date:	5.17.24
project:	Hyde Park Middle School
by:	Michael Rigby
subject:	Addendum 03

CONTRACT ADDENDUM 03

PLAN - LEVEL 01
-AREA F - SLAB & FOUNDATION

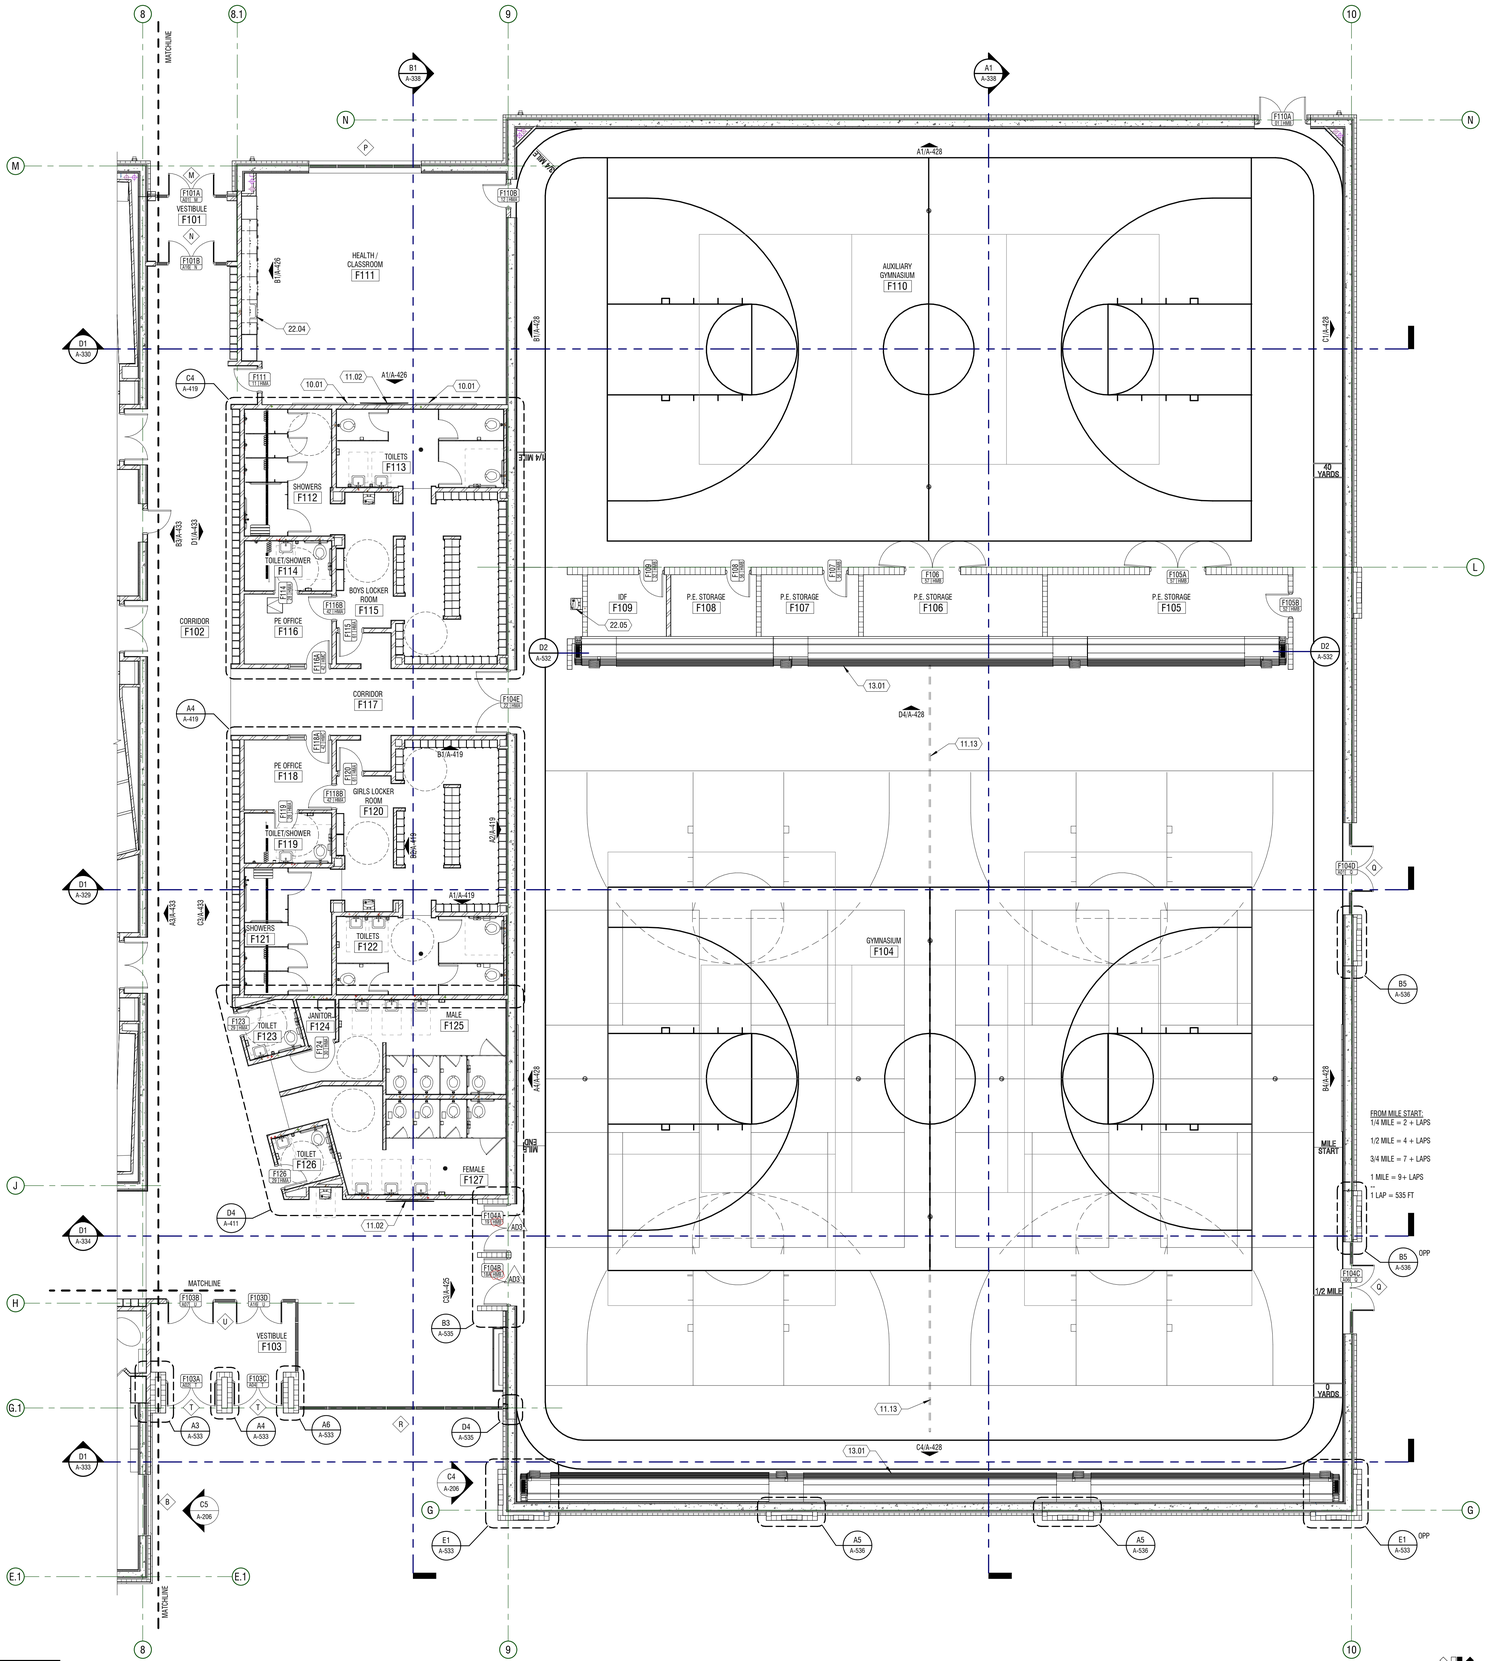
03.16 A-116.0 – PLAN – LEVEL 01 – AREA F – SLAB & FOUNDATION
- Rough Opening in ICF along grid 9 updated.

PLAN - LEVEL 01 - AREA F - ANNOTATION

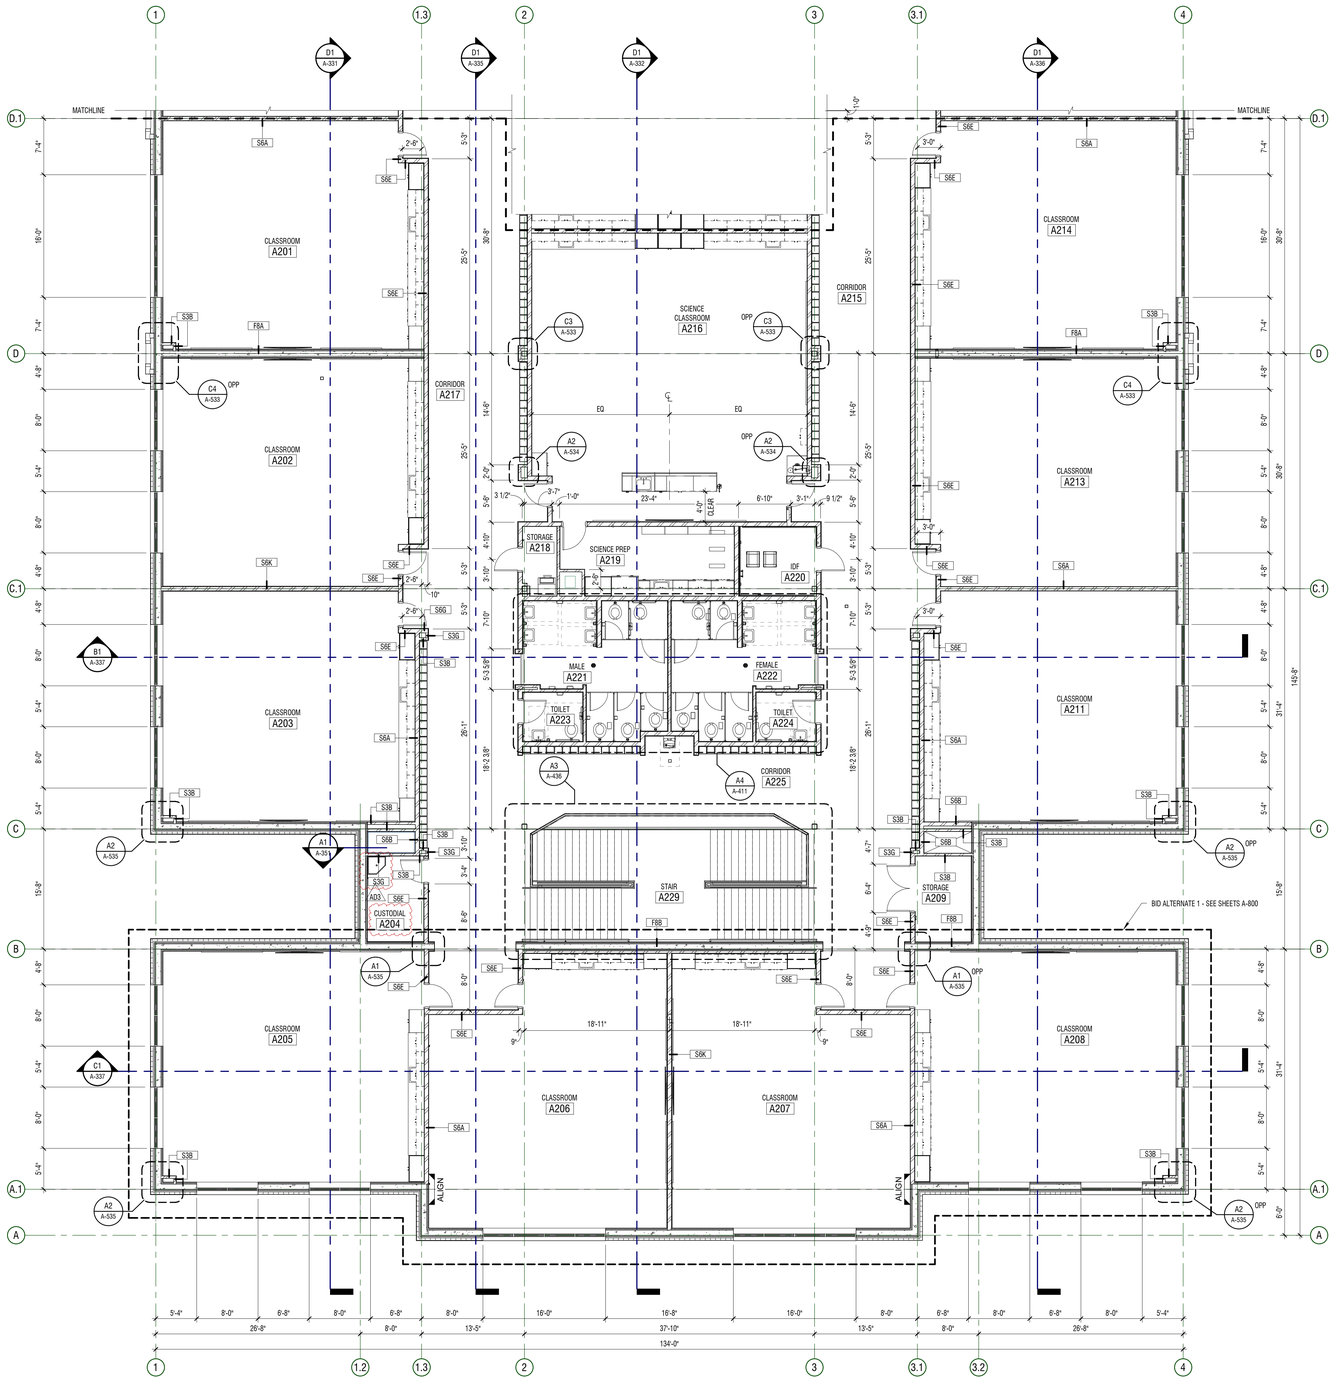
03.17 A-116.2 – PLAN – LEVEL 01 – AREA F - ANNOTATION
- Doors F104A and F104B frame types changed to HMB

2. **Civil – Site Plan – Northeast, Sheet C-204.**
   a. **CORRECTION –** Keynote in the middle of 200 South should be #14

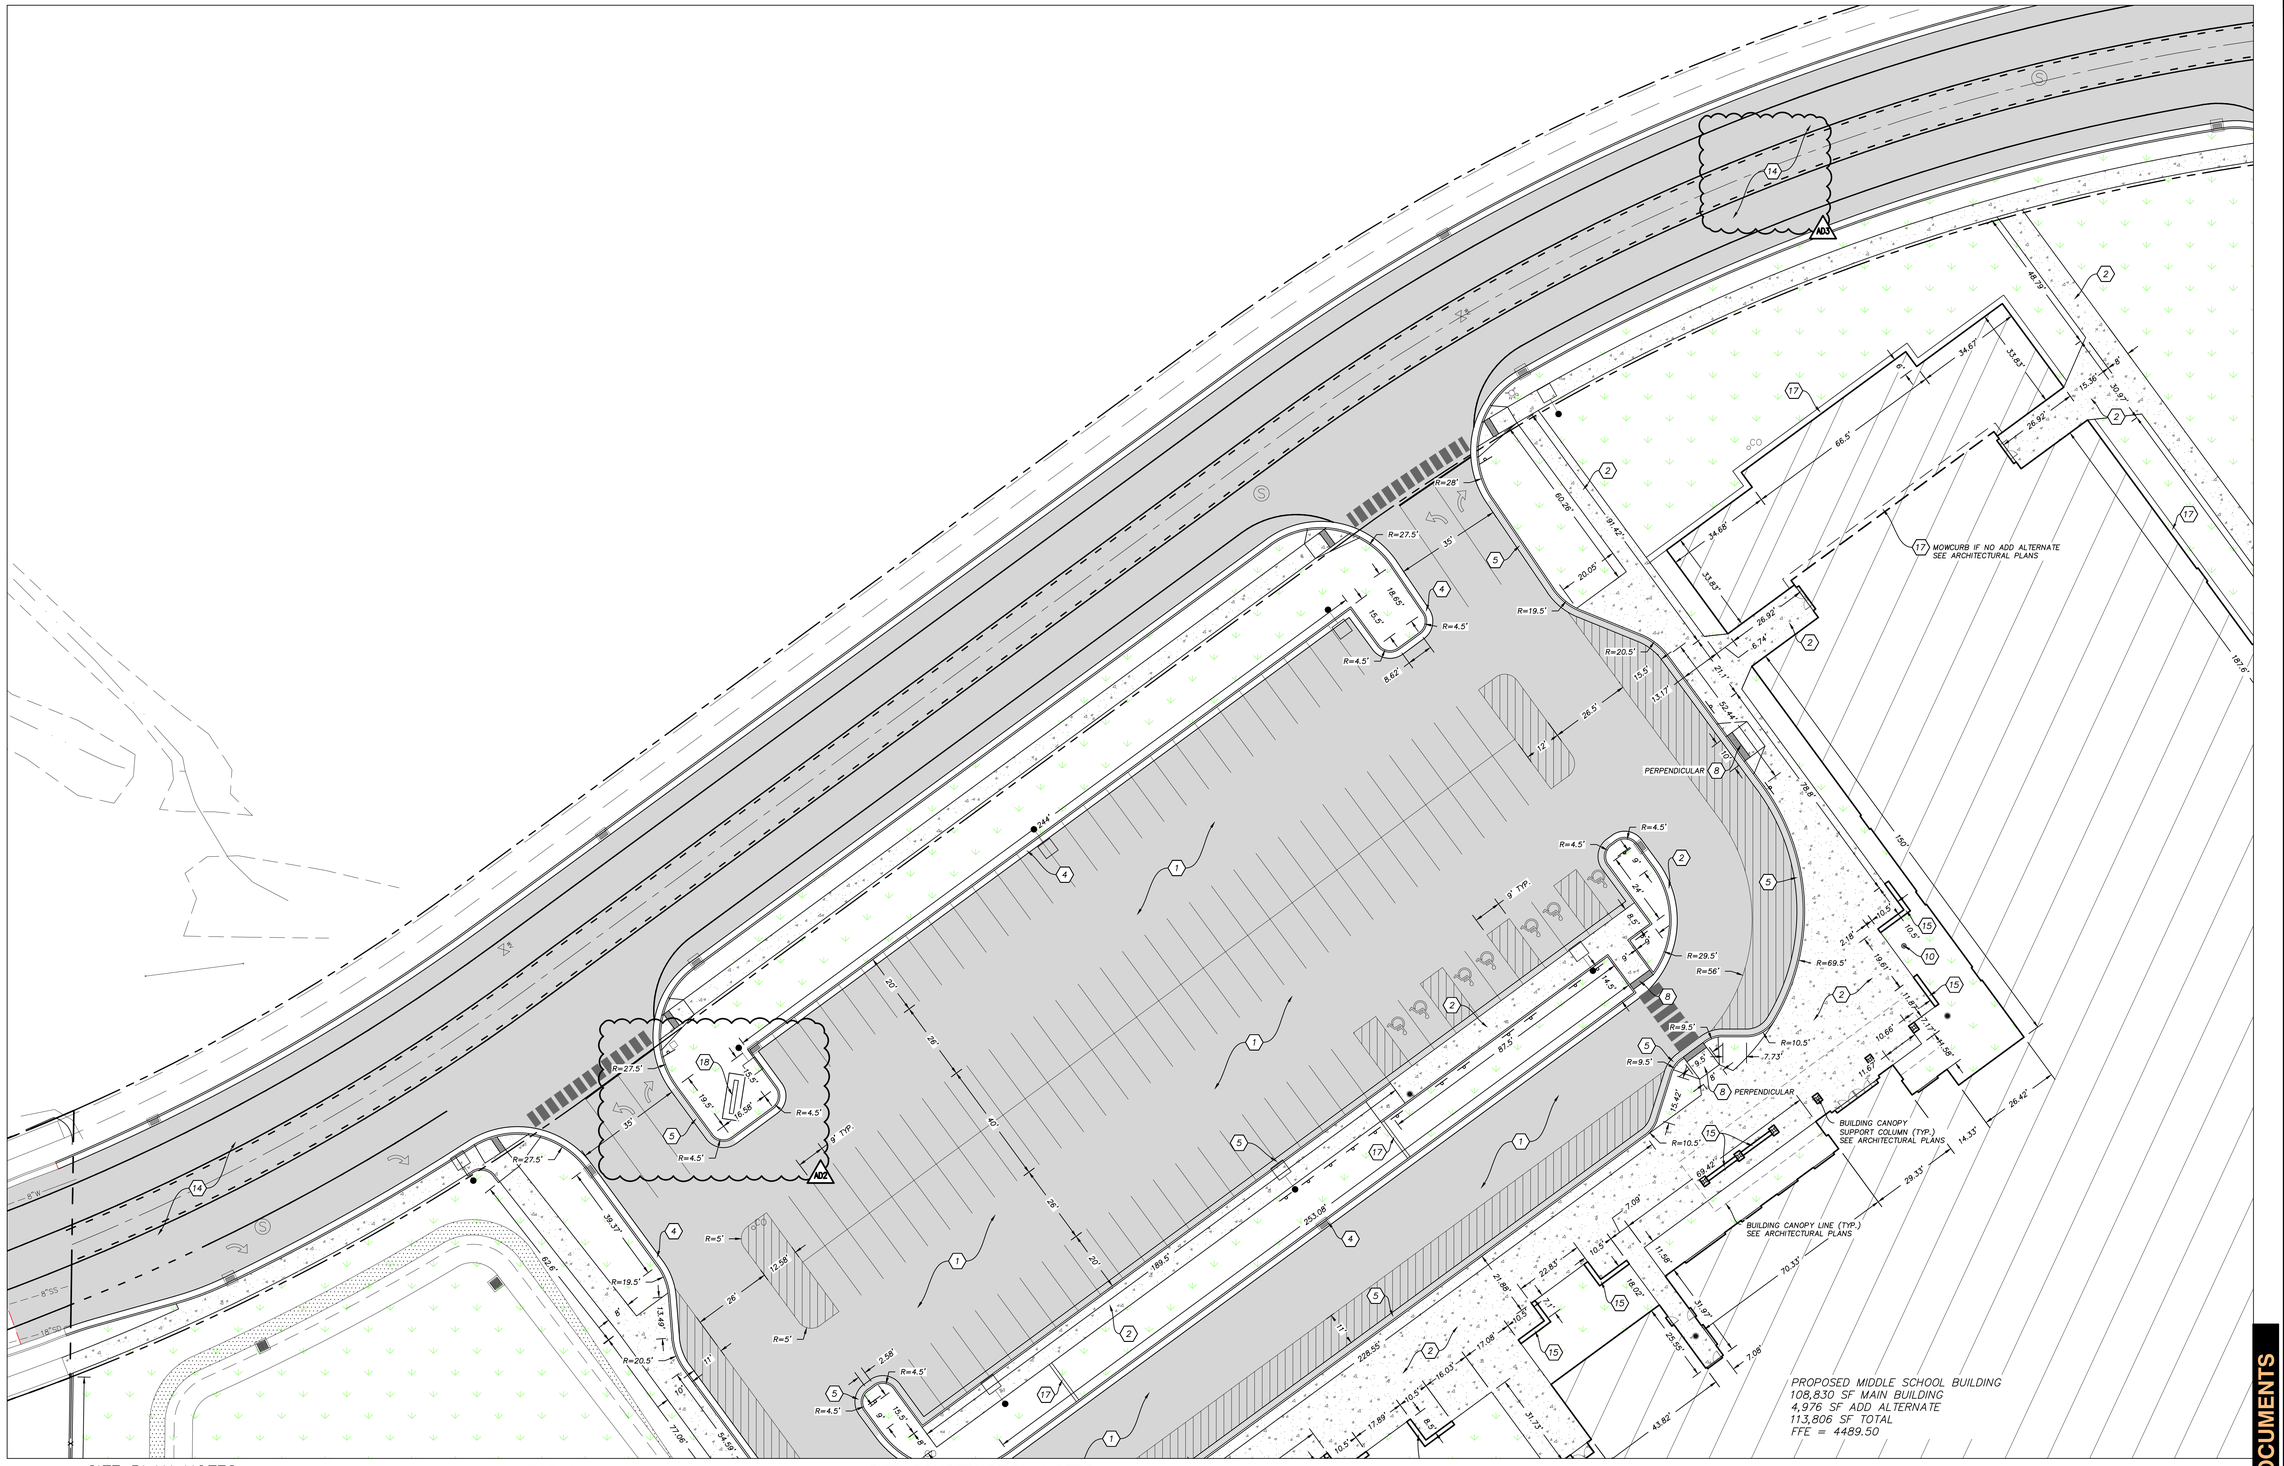
01 DWA **QUESTION 1**: *Sheet C204 shows keynote 10 in the middle of the roadway. That keynote is for a BB standard. Is that where you want it? Or should it be keynote 14.*

ANSWER: See Hyde Park Civil Items, Addendum 3

CIVIL- SITE PLAN NORTHWEST

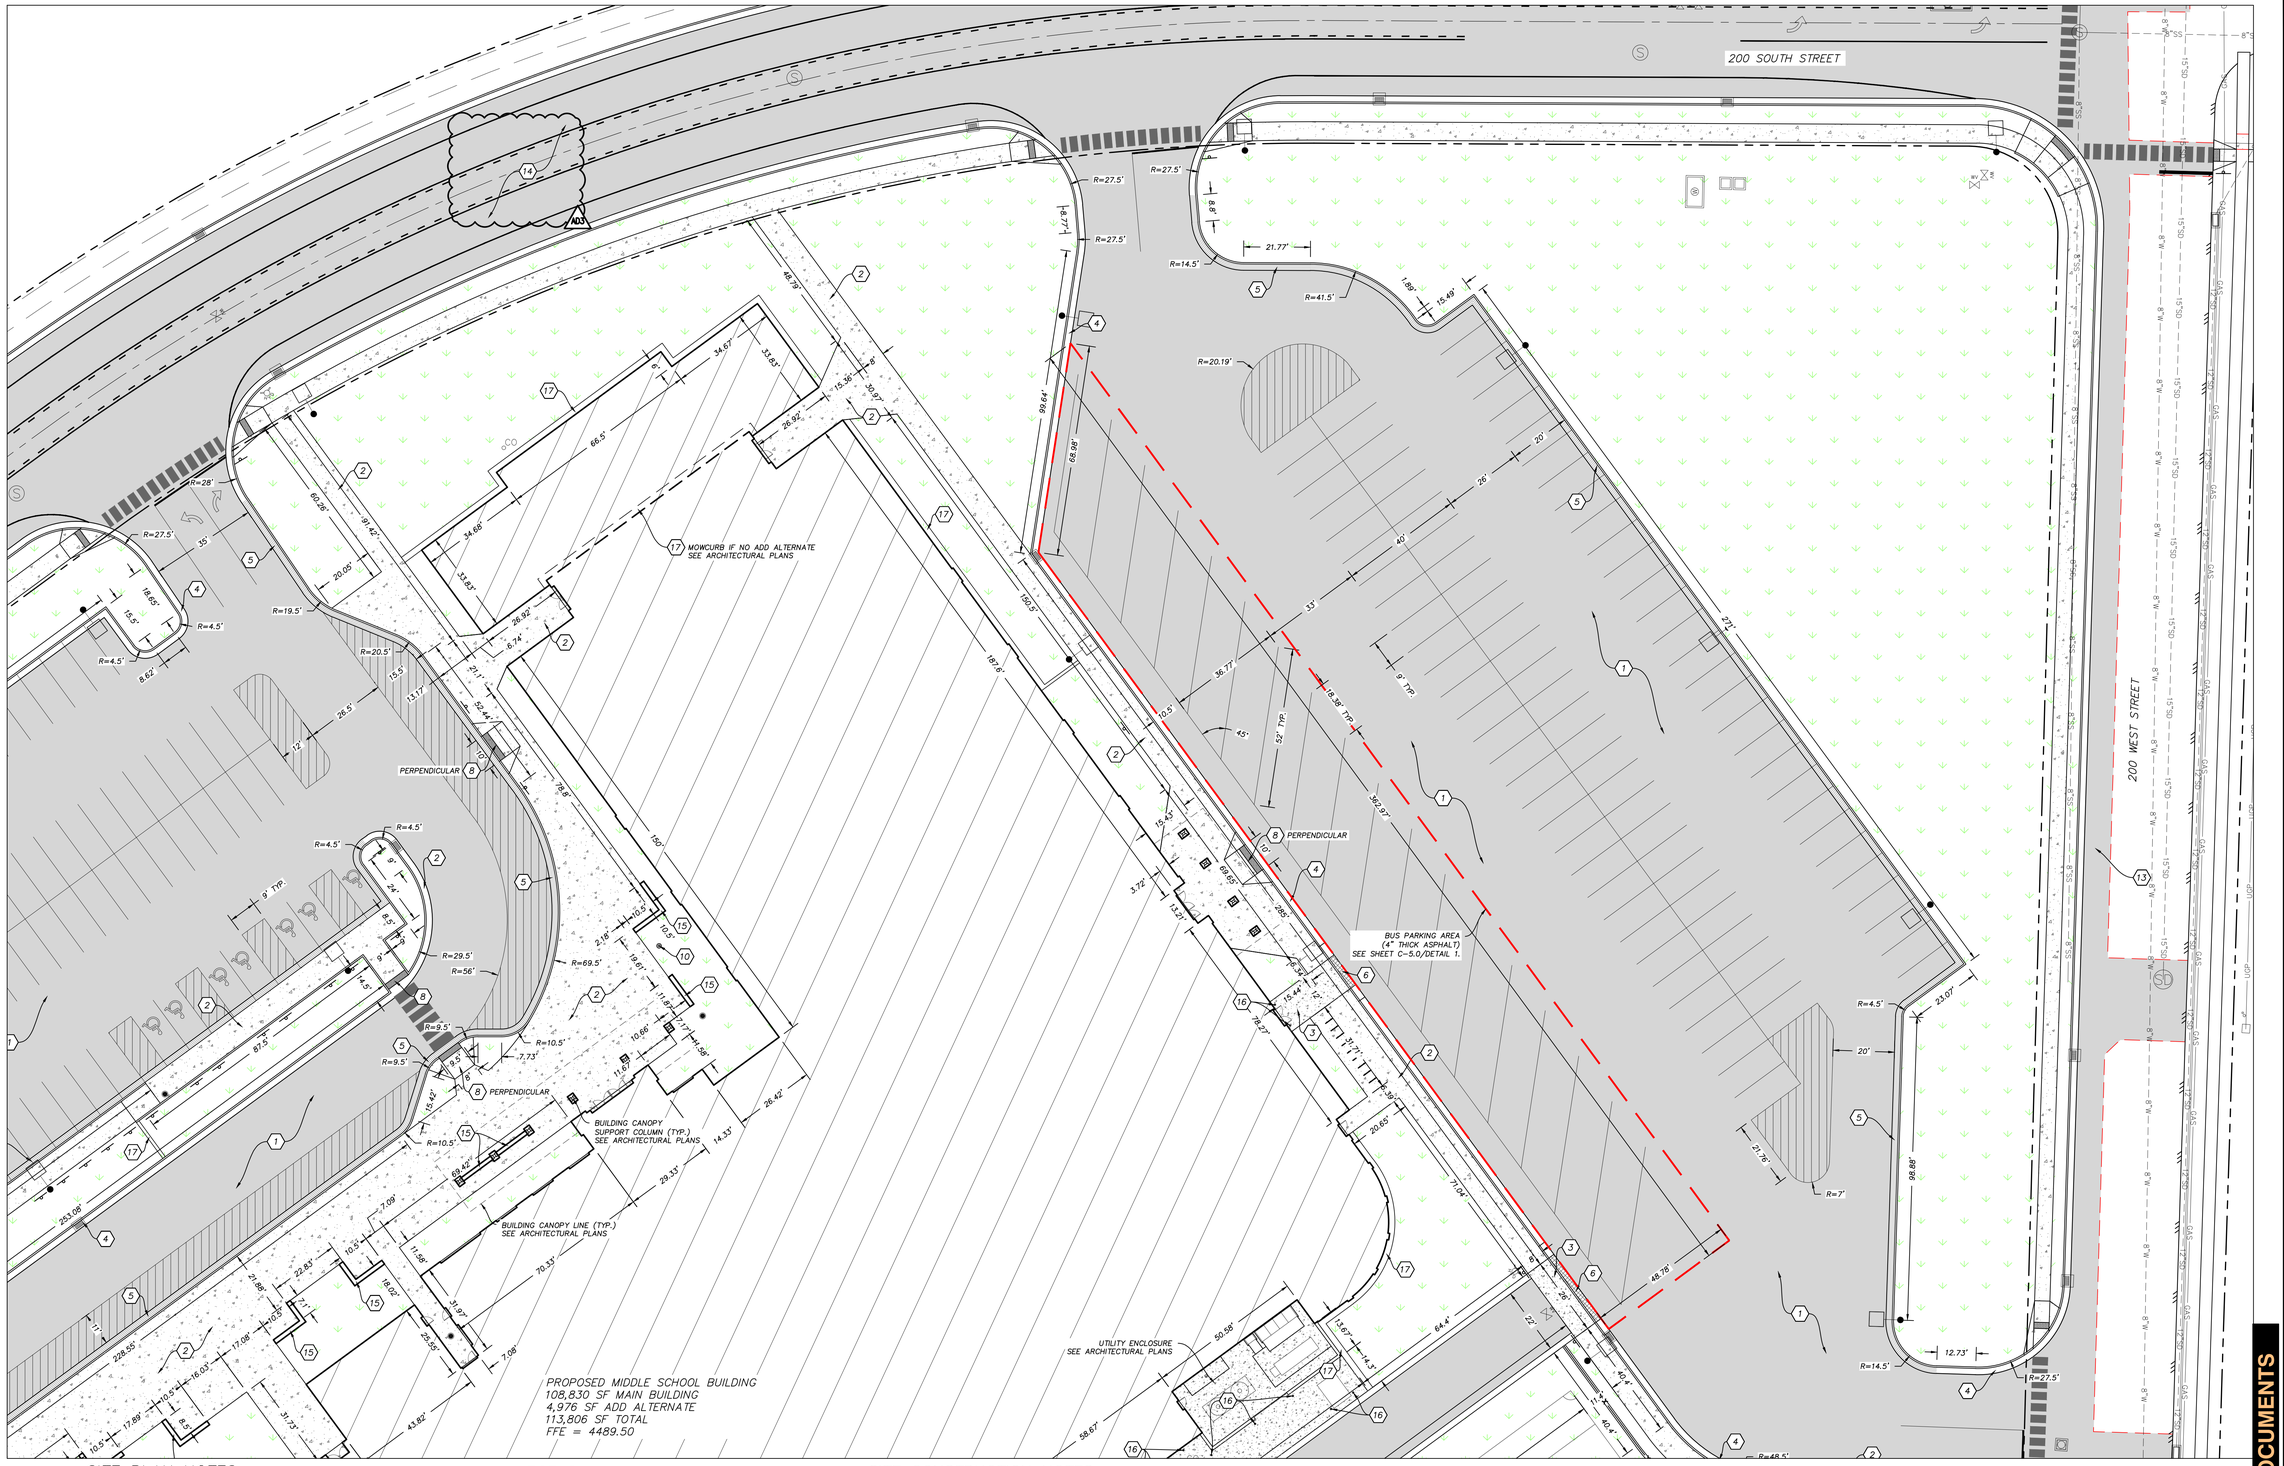
1. **Civil - Site Plan – Northwest, Sheet C-203.**
   a. **CORRECTION –** Keynote in the middle of 200 South should be #14.
